Construction Change Directive

PROJECT: *(name and address)*
Highland Township Fire Station 2
PIA #18-122B

CCD INFORMATION:
Directive Number: 001
Date: July 13, 2021

“EXHIBIT A” – CCD NO. 1

A4-01 REFLECTED CEILING PLANS & DETAILS

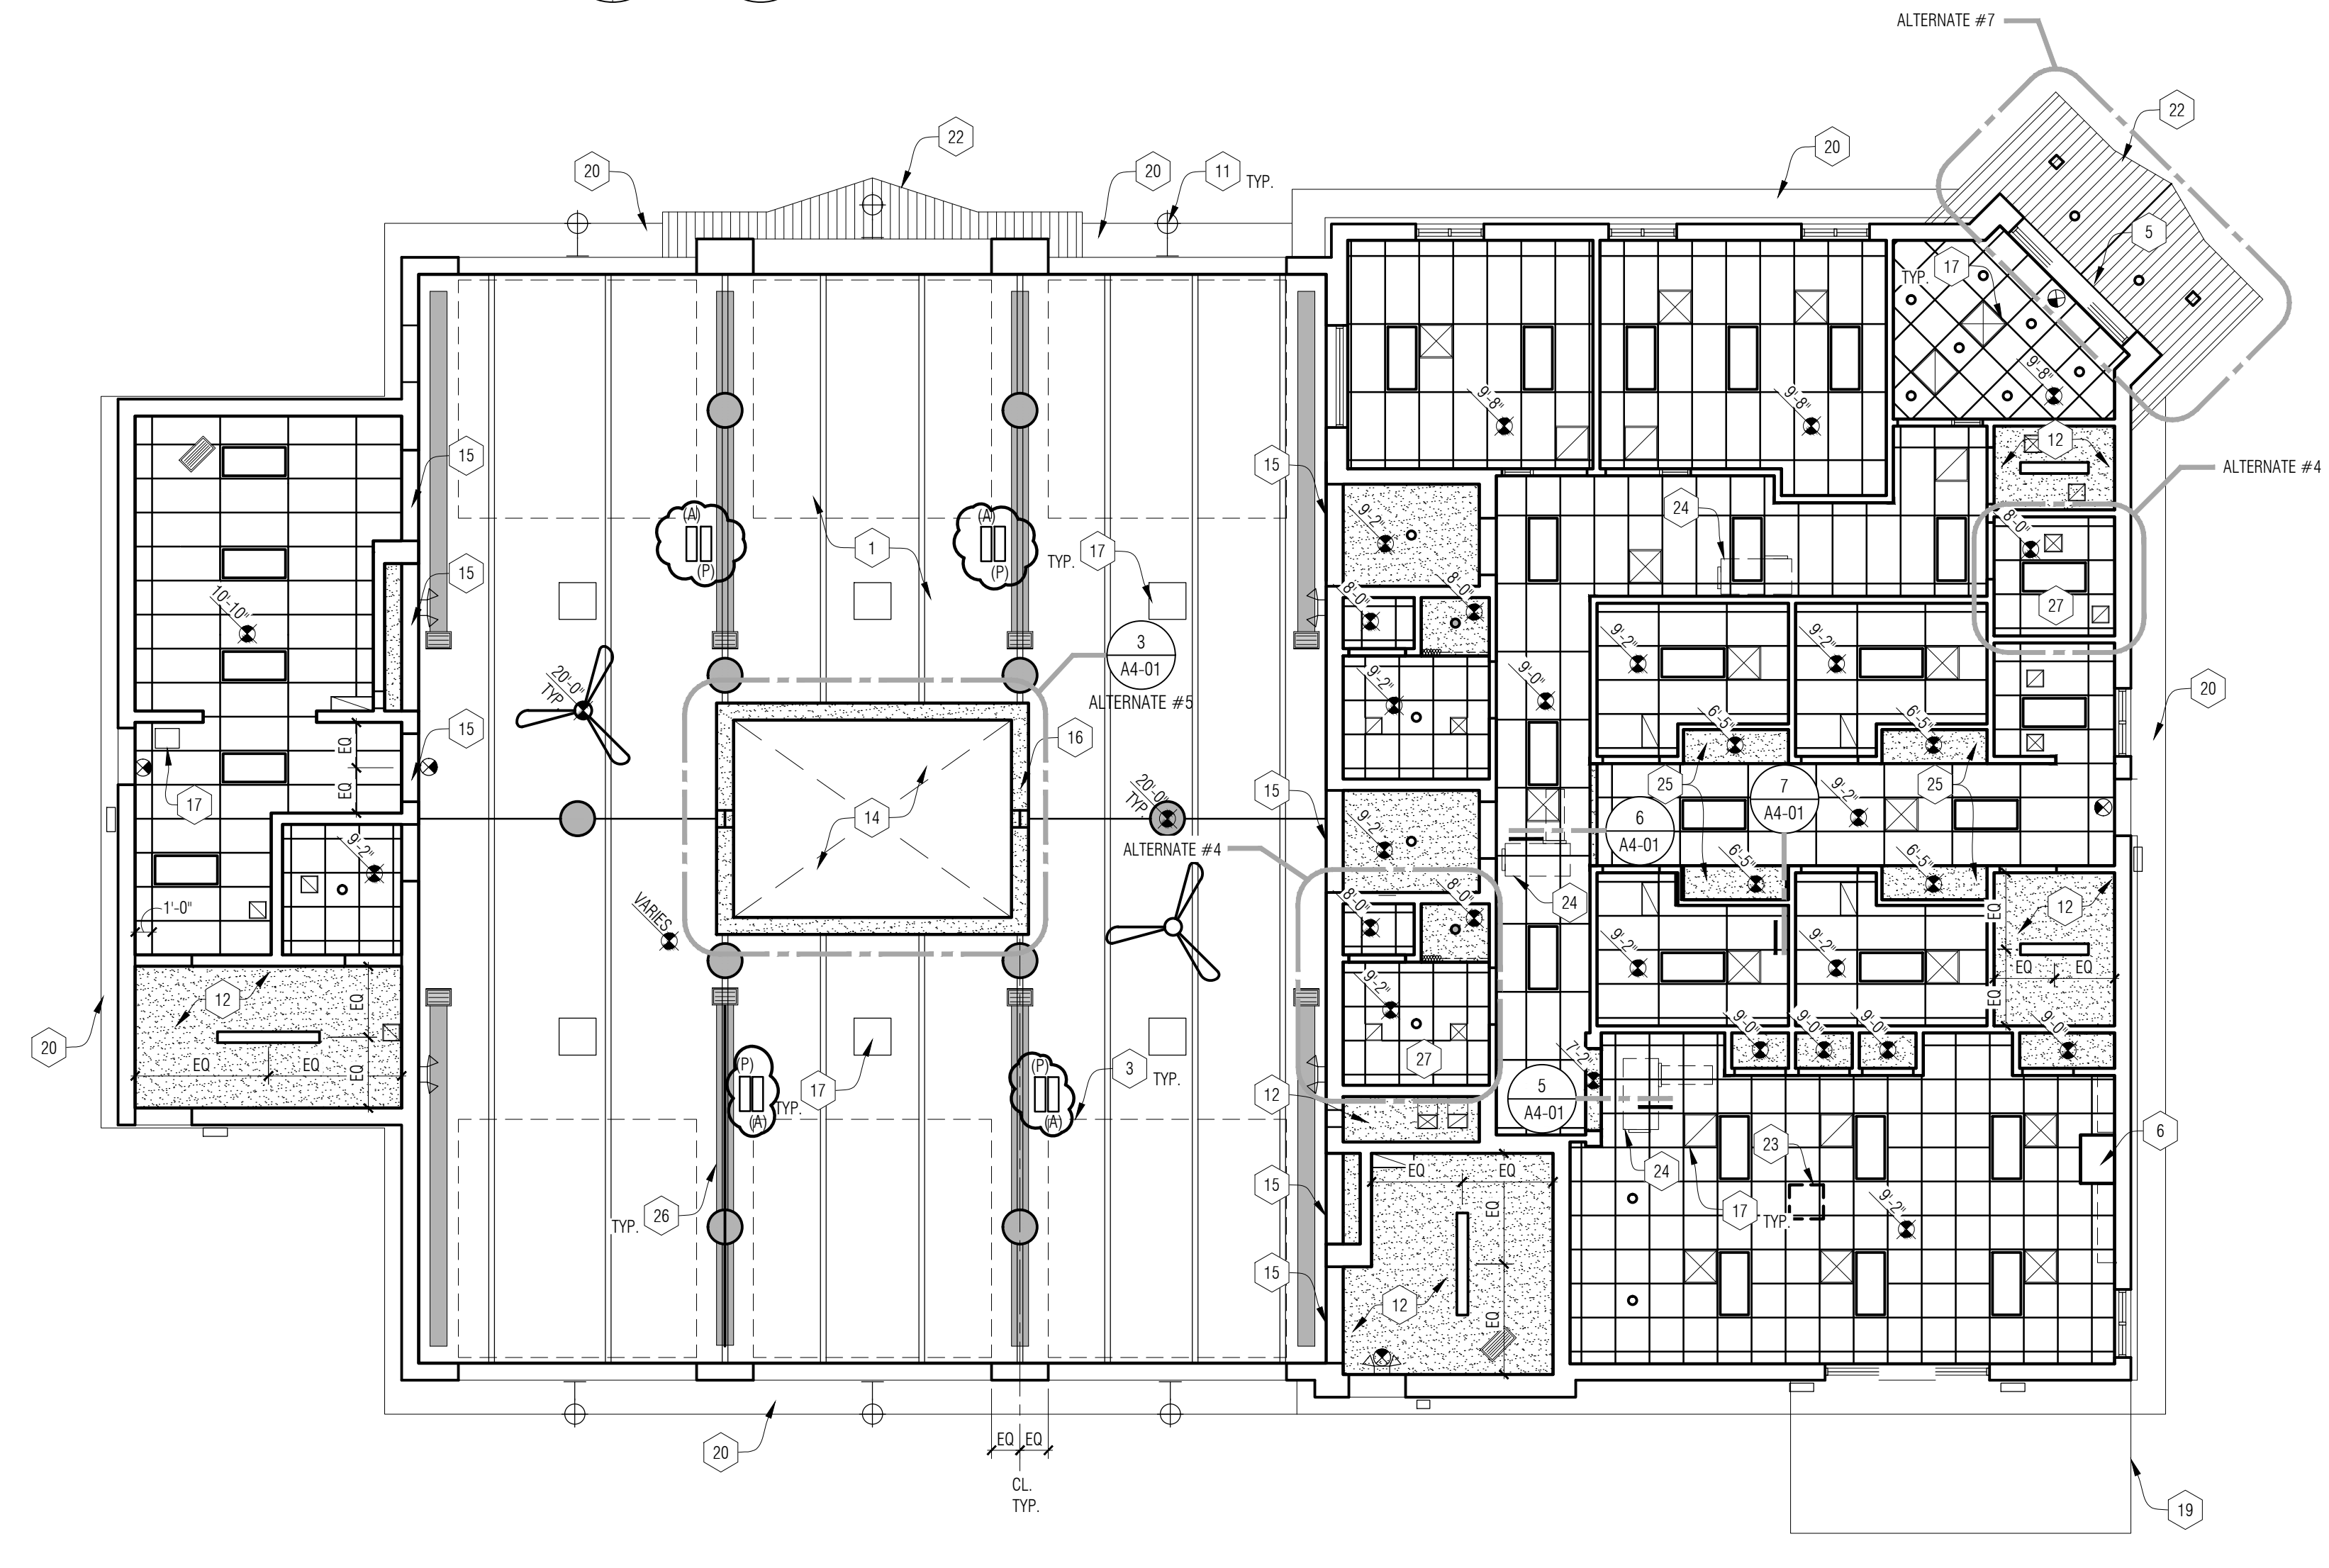
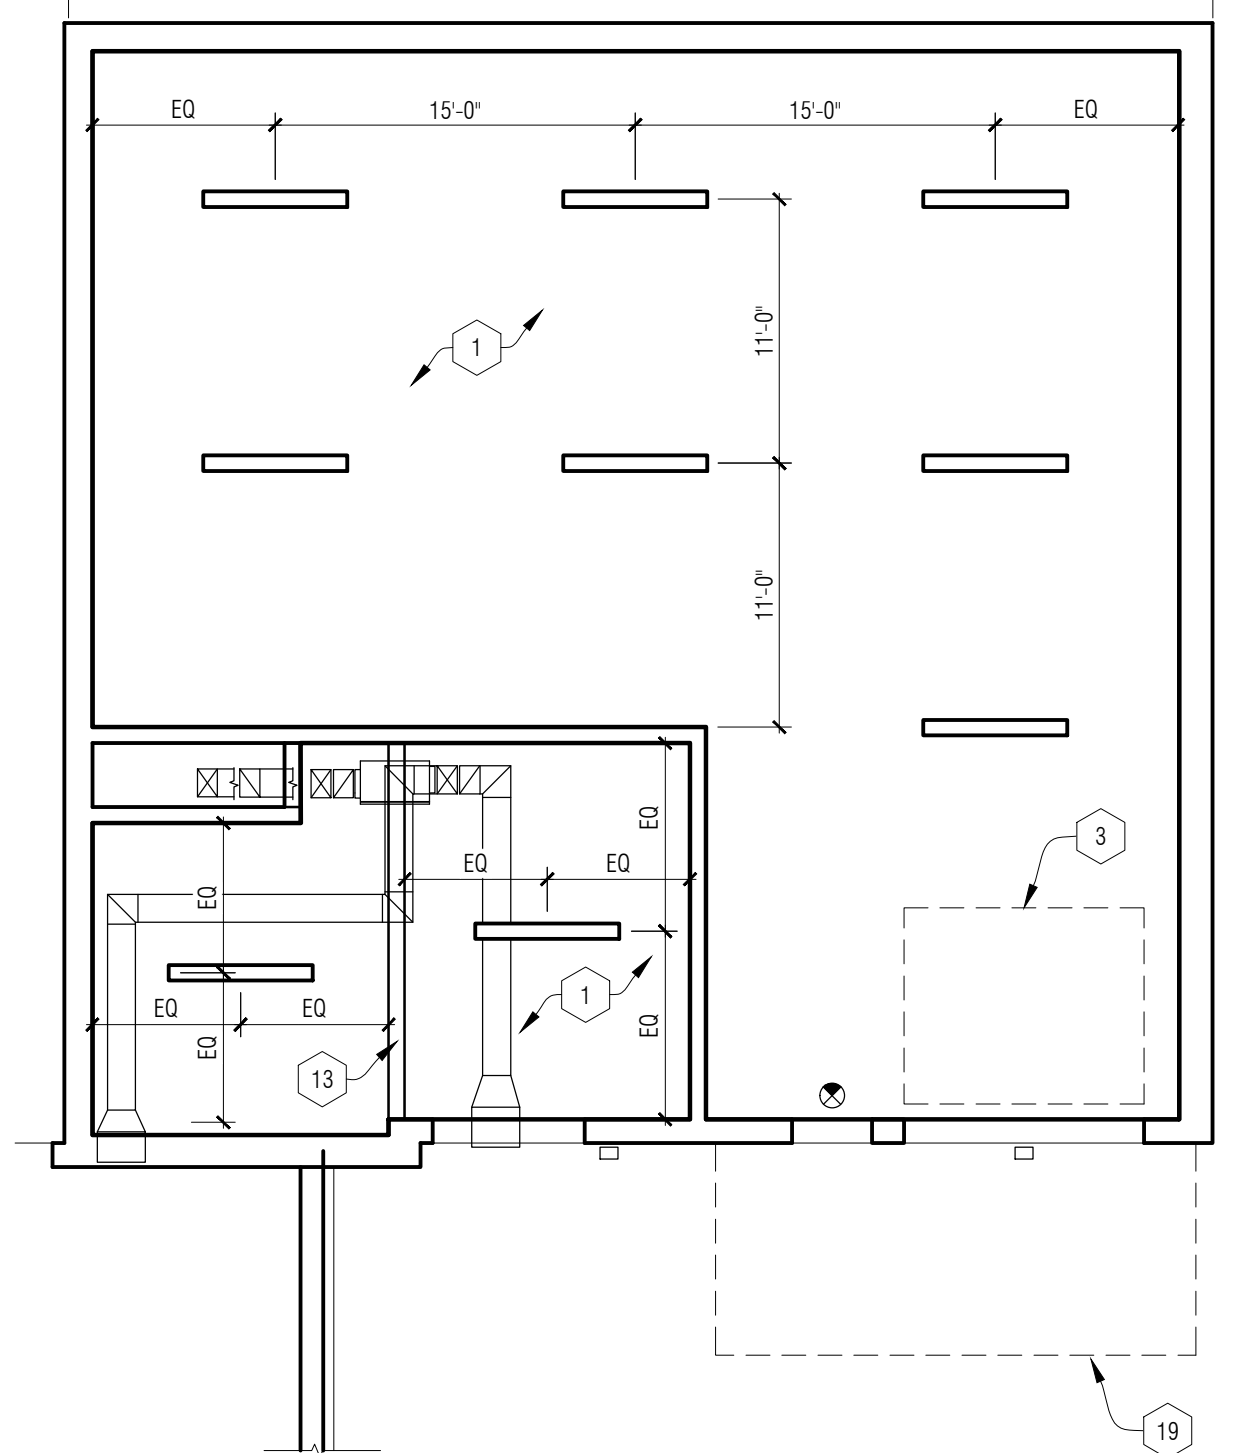
- A. Add (4) four air reel and power chord drops to the ceiling of Apparatus Bay 121.
- B. Added a symbol for the reels on the Ceiling Symbol Legend.
